STAFF REPORT
ITEM NO. Three.

DATE: *September 12, 2016*

COA REQUEST: *Guidelines Revisions*

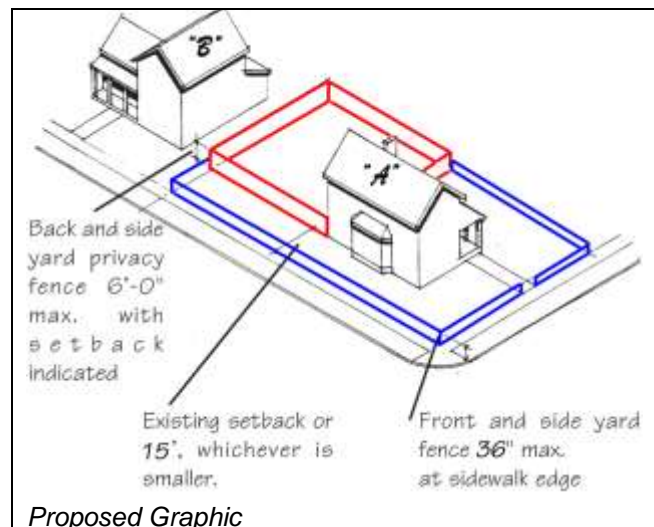
On page 61, there is text proposed to be changed on the height of fences.

When the backyard of a corner property "A" abuts the front yard of the adjacent property "B", and when property "A" installs a fence taller than 36" abutting the street, it may diminish the front yard of property "B". The zoning ordinance states that between a required building setback line and a street right-of-way, the maximum height shall be lower than other fences in the rear yard. The zoning ordinance would require the street facing privacy fence (greater than 4' tall) to be set back the distance of the side yard setback of 10% of the lot or 5 feet. Those five feet may differ from the actual setback of the primary structure. The HDC may be stricter than the zoning code, but cannot be less strict without the project having a public hearing with the Planning Commission or the Board of Adjustment.

Fences in side and rear yards with street frontages should not impede views of adjacent houses that have a different orientation. For those fences, the location of the fences that are in excess of 36", as shown in red, should be the wall of the primary building or 15', whichever is less.
